ADDENDUM #1

Project # 13-0184 **Date:** May 6, 2015
Project: Department of Veterans Affairs **A/E Firm:** C2AE
 Saginaw, Michigan
 Aleda E. Lutz Medical Center **Project Manager:** Kelly Jo Homic
 SPS & Logistics Storage Area Renovation

Owner: Department of Veterans Affairs
 VA Medical Center CSC Michigan (90C)
 1500 Weiss Street
 Saginaw, Michigan 48602

BASEMENT FLOOR PLAN
1/8" = 1'-0"

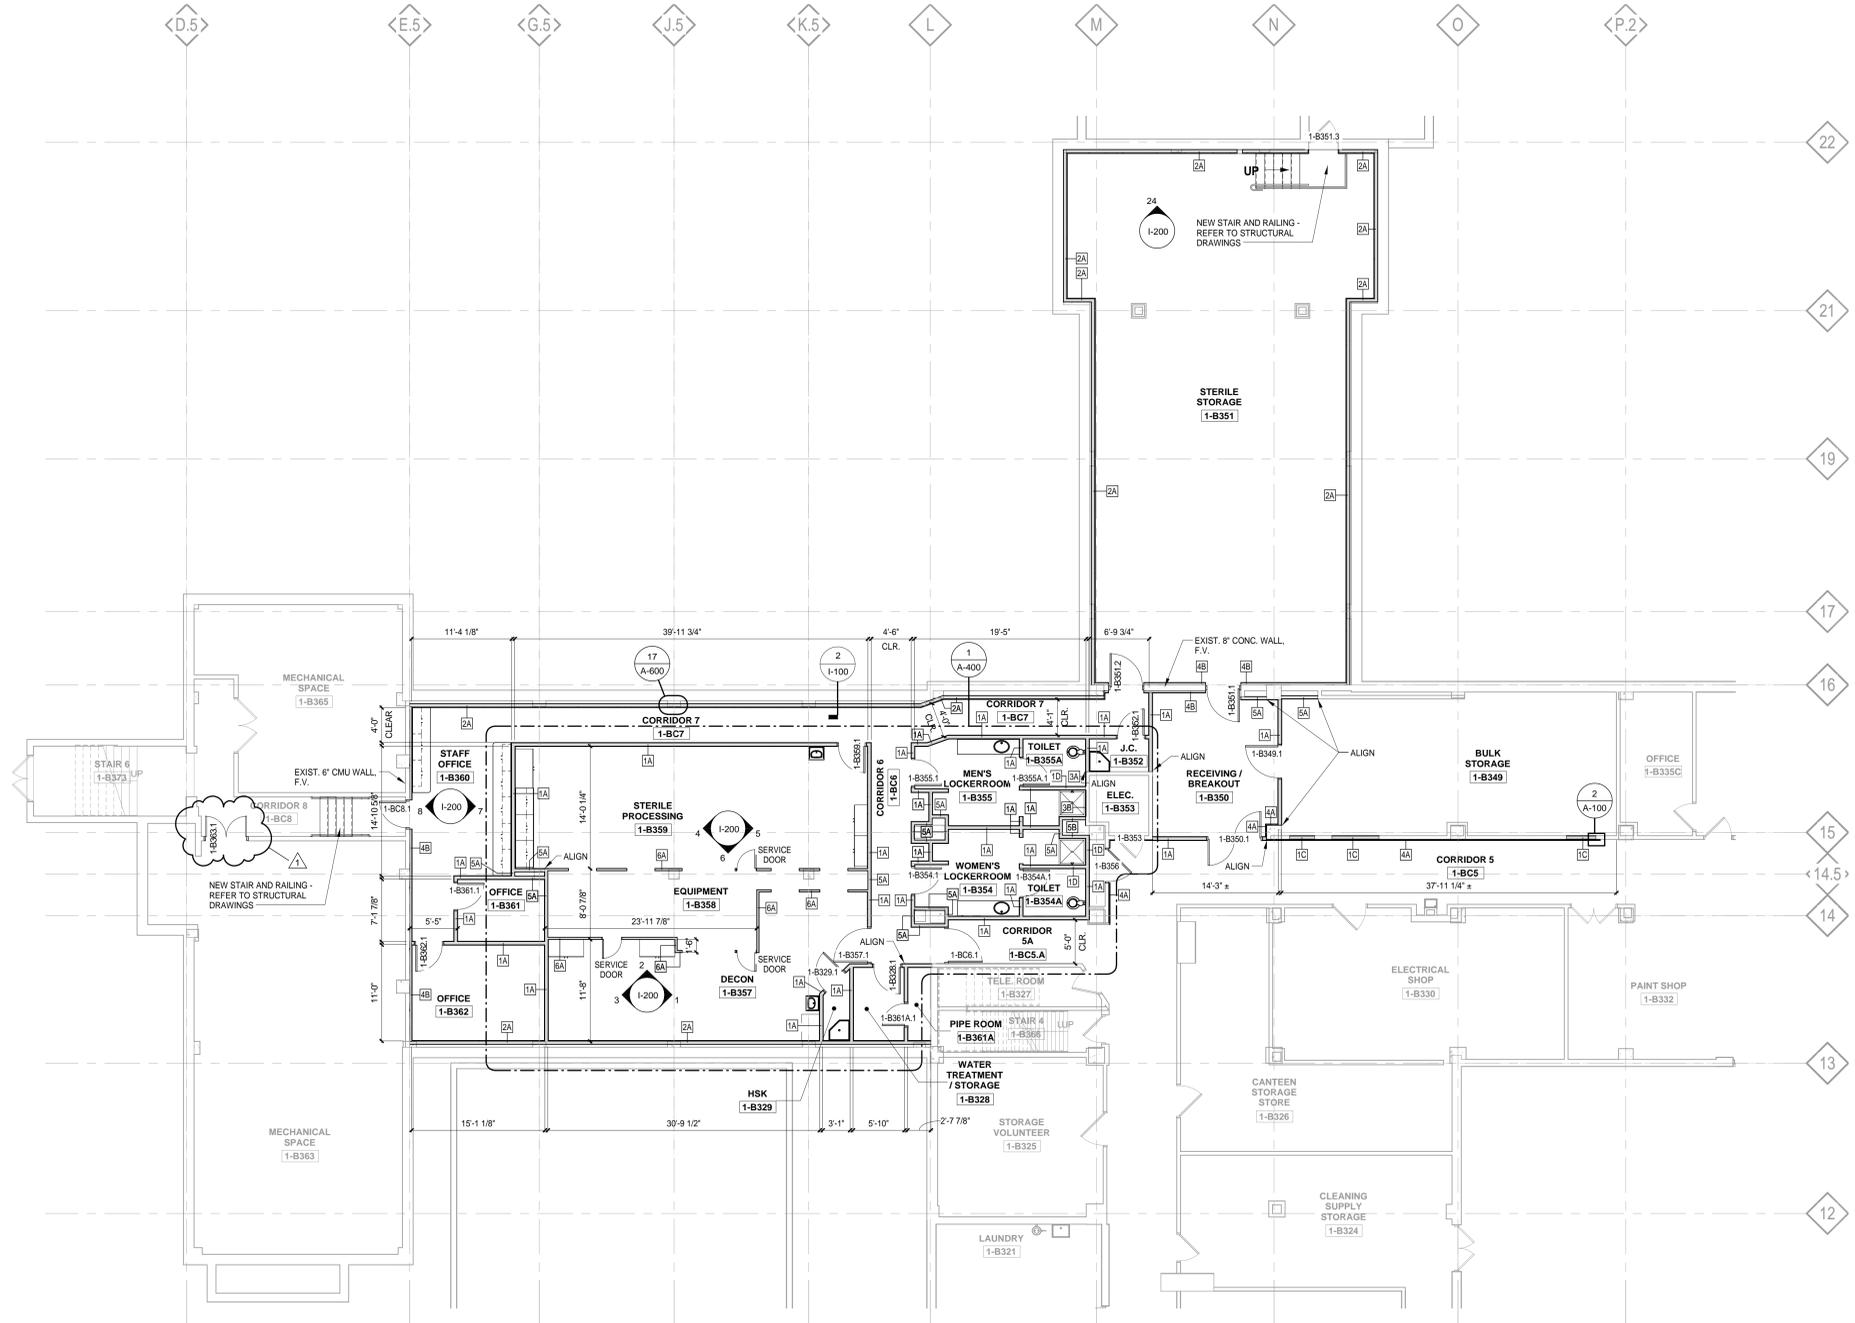
A1.6 Refer to Sheet A-100 (reissued):

- REVISE Floor Plan to include new pair of doors into Mechanical Room B363 as shown.

BASEMENT PLUMBING DEMOLITION PLAN
 1/8" = 1'-0"

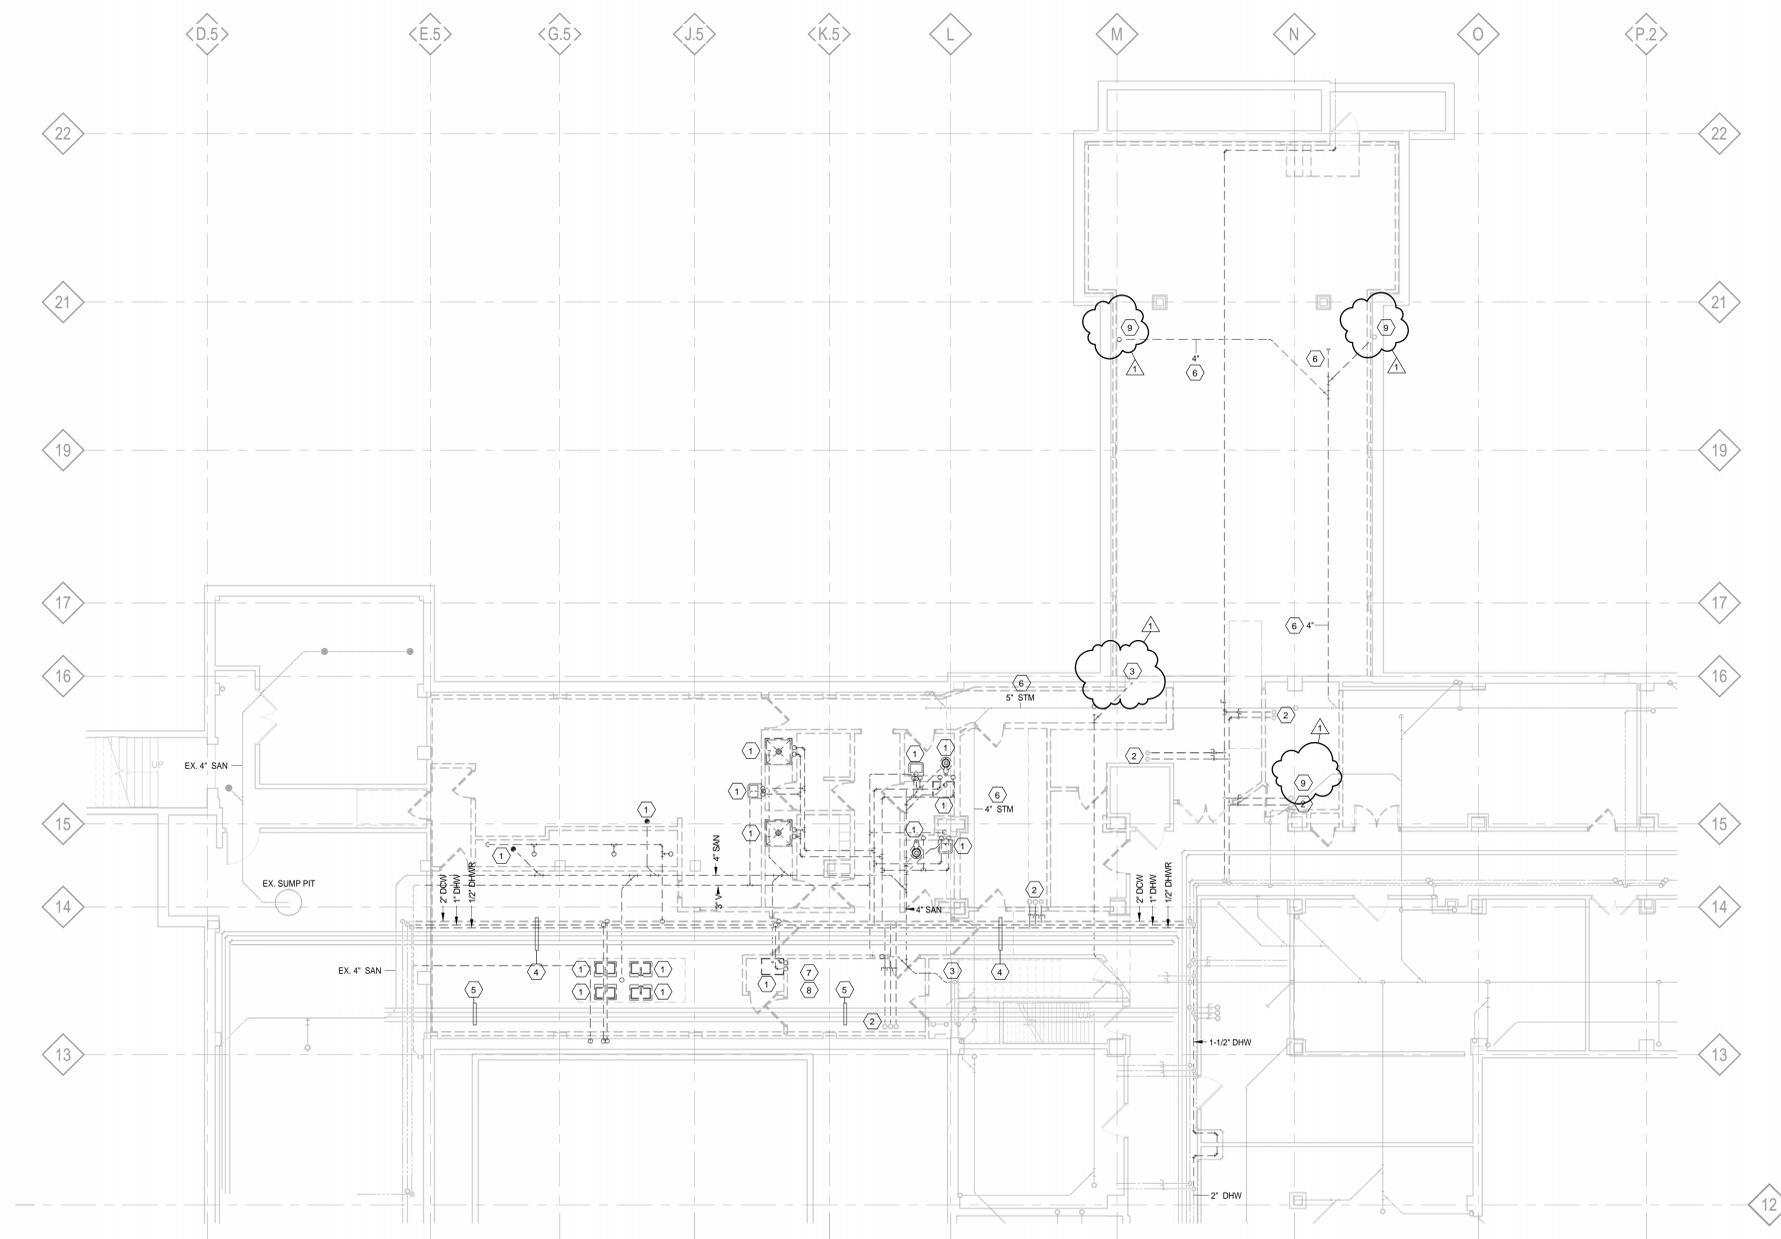
A1.8 Refer to Sheet PD-100 (reissued):

- REVISE Keynote 3 to read, "Contractor shall remove existing sanitary riser to just below first floor."
- ADD Keynote 9 to read, "Contractor shall remove existing storm riser to just below first floor."

- PLUMBING DEMOLITION KEY NOTES:**
- 1 REMOVE PLUMBING FIXTURE.
 - 2 DOMESTIC WATER RISERS TO FIRST FLOOR TO REMAIN.
 - 3 CONTRACTOR SHALL REMOVE EXISTING SANITARY RISER TO JUST BELOW FIRST FLOOR.

- 8 CONTRACTOR SHALL REMOVE EXISTING CART WASH EQUIPMENT AND ASSOCIATED PIPING IN ITS ENTIRETY.
 - 9 CONTRACTOR SHALL REMOVE EXISTING STORM RISER TO JUST BELOW FIRST FLOOR.

BASEMENT PLUMBING PLAN
 1/8" = 1'-0"

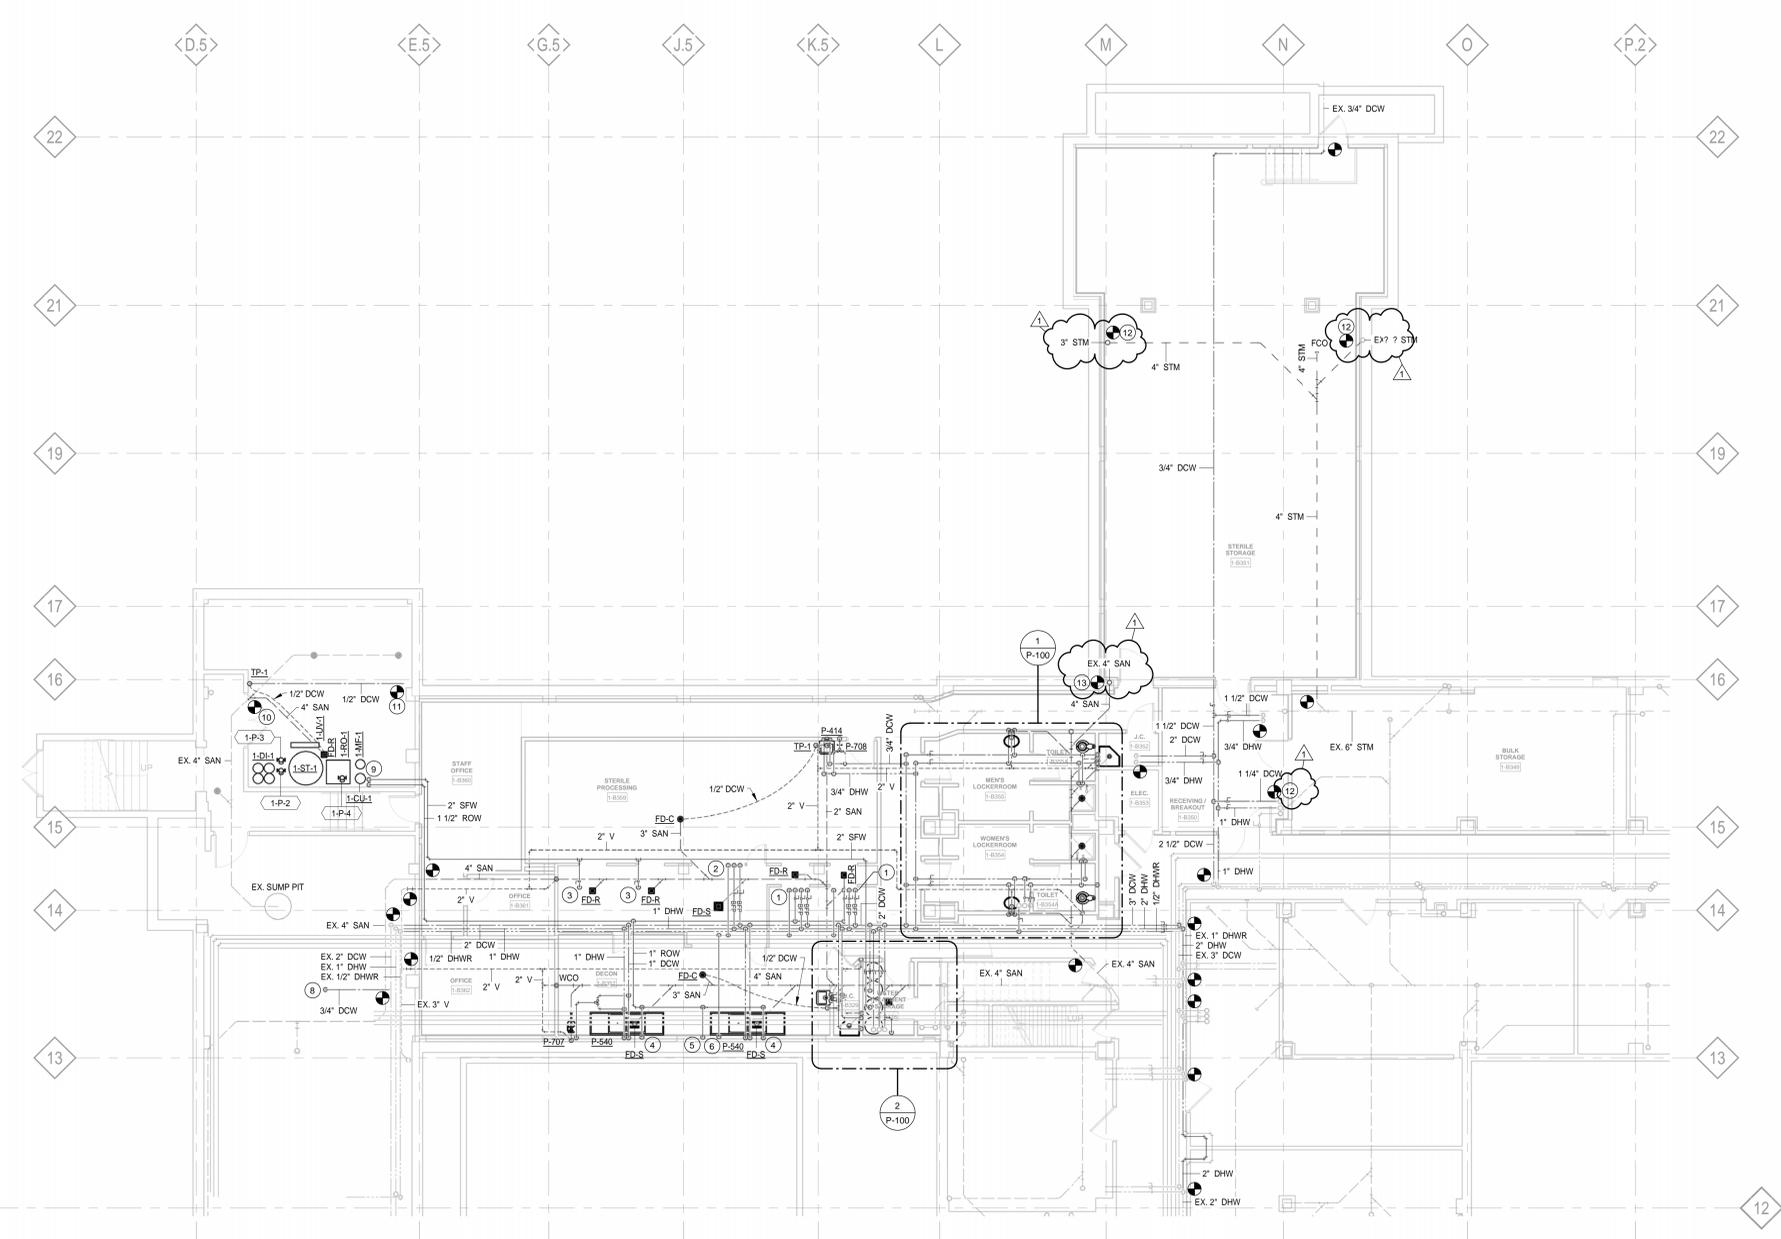
A1.9 Refer to Sheet P-100 (reissued):

- ADD Keynote 12 to read, "Connect new storm riser to existing storm riser in basement ceiling space."
- ADD Keynote 13 to read, "Connect new sanitary riser to existing sanitary riser in basement ceiling space."

- SAWCUT FLOOR FOR NEW 4" SANITARY. CONNECT TO EXISTING.
 - CONNECT 1/2" DCW TO EXISTING DCW MAIN.
 - CONNECT NEW STORM RISER TO EXISTING STORM RISER IN BASEMENT CEILING SPACE.

- CONNECT NEW SANITARY RISER TO EXISTING SANITARY RISER IN BASEMENT CEILING SPACE.

1 TYPICAL AHU SECTION DETAIL
N.T.S.

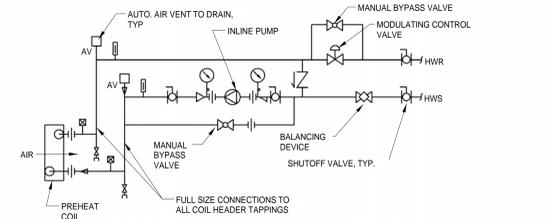
A1.10 Refer to Sheet M-500, Detail 1 (reissued):

- ADD the following note: "Note: Unit shall be shipped in splits where the shipping sections can fit through a 3'-10" opening."

NOTE: UNIT SHALL BE SHIPPED IN SPLITS WHERE THE SHIPPING SECTIONS CAN FIT THROUGH A 3'-10\"/>

3 ACCESS CONTROL DOOR DETAIL (TYPICAL) N.T.S.

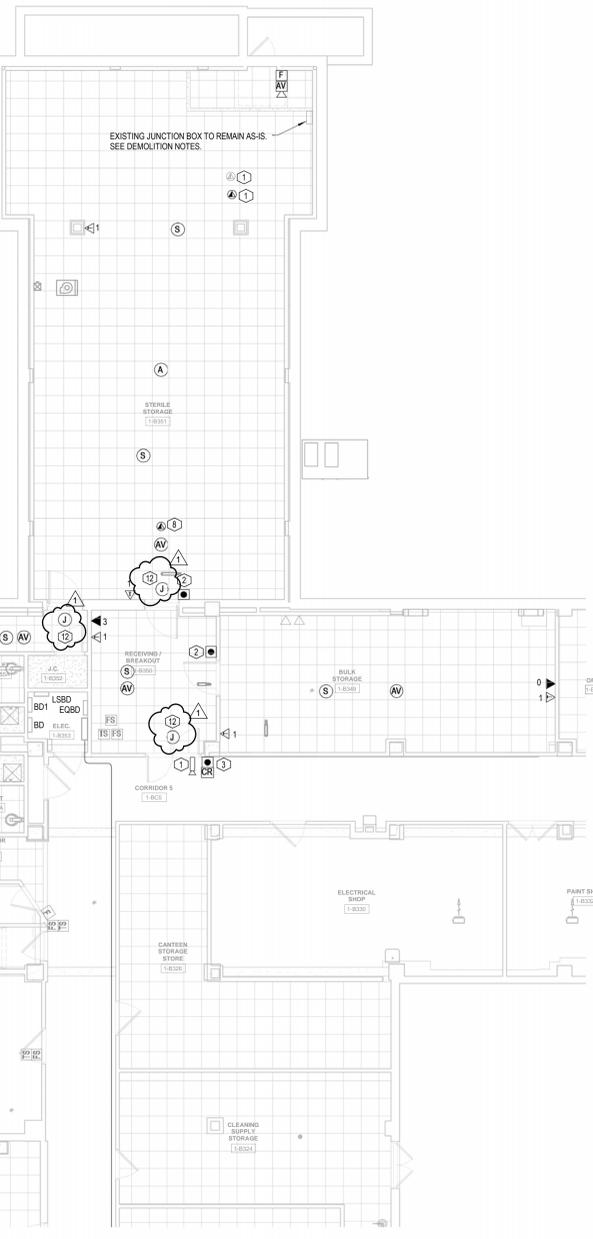
- REVISE Basement Special Systems Plan to show locations of Access Control Door Controller boxes mounted above ceiling.
- ADD Special Systems Keynote 12 as shown on drawing.
- ADD Note 4 to both Detail 2 and Detail 4 as shown on drawing.
- REVISE Detail 3 as shown on drawing.
